Case reference: PAX91.323780

Ballinlee Wind Farm – Dooley Family Submission

Location: Camas South, Bruff, County Limerick, V35 EH72

Date: 16th November, 2025

Figure 2: Groundwater level was at 1.4m below ground level in August 2024 (Appendix 8A)

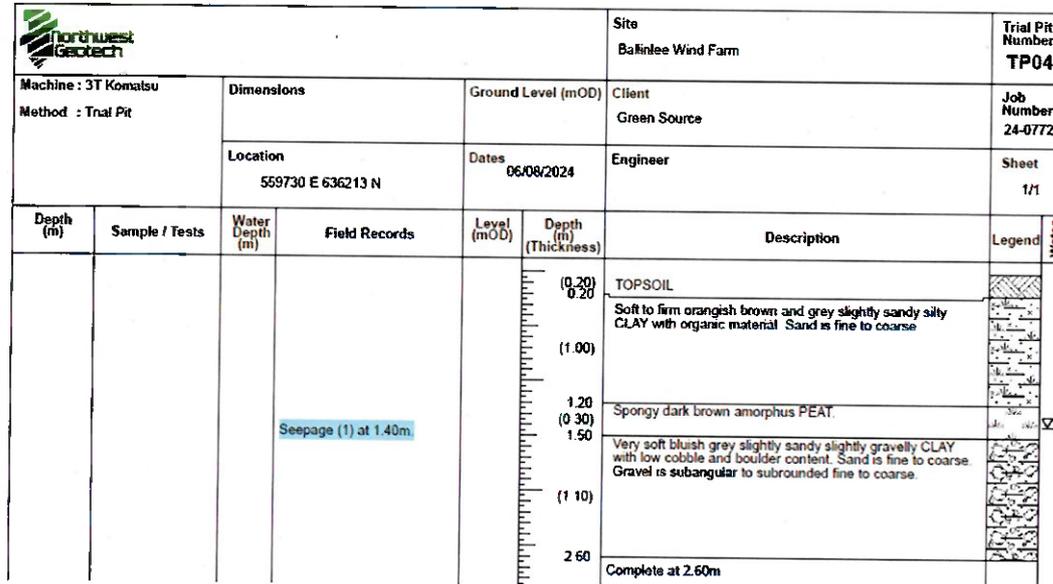
As residents, we know that a highly variable water table is a year-round issue at this site. In justifying their decisions about turbine location, the developer's trial pit data show that

water ingress was evidenced at just 1.4m below ground level at Trial pit 4 at the driest time of the year – in Aug 2024 (from Appendix 8A). This is just 670m from our home (fig 4).

This section of the EIAR, prepared by National Geotech (Appendix 8A) acknowledges the water problem and states that the design must factor this issue in. However, there is no evidence of the developer following this advice. Instead, they abide by their pre-determined design. This is borne out by their not considering alternatives as evidenced in Chapter 3 of the EIAR.

Figure 9: Email exchange with the developer's representatives in August 2025, when we were refused details of the beneficiaries of the development based on GDPR restrictions.

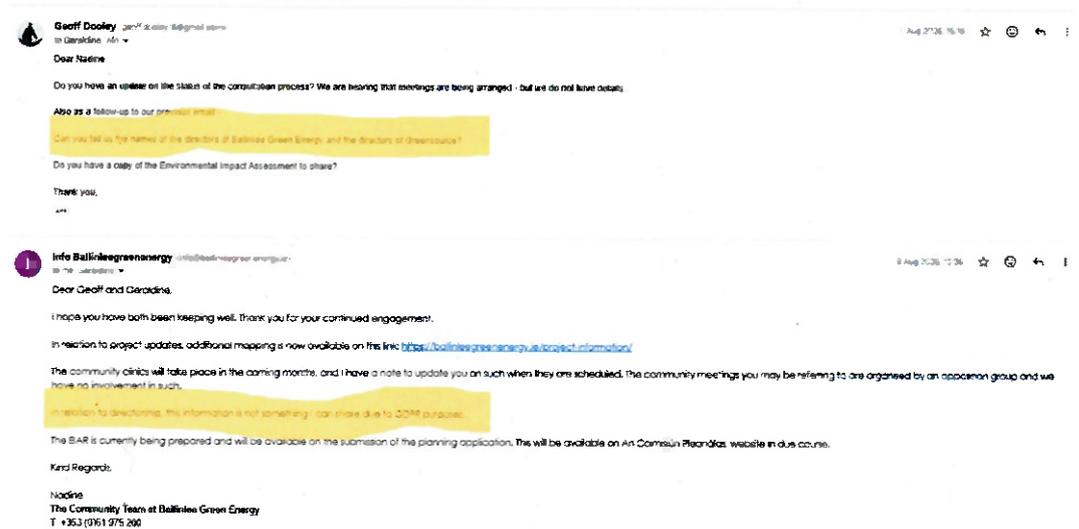
We are particularly concerned about the developer's avoidance and lack of transparency about of the project beneficiaries. Given the the scale and impact of what the developer was proposing to impose on our local area we believe it is reasonable to ask for the developer's details and submitted a request on the 1st Aug, 2025. On the 8th of Aug 2025, the

developer's representative responded and refused to share details on the grounds of GDPR. See the email below:

We challenged this reason on the basis that GDPR is not a basis for refusing to share information that is of legitimate public interest. In their response, the developer agreed but continued to refuse to share details of the project beneficiaries. See below:
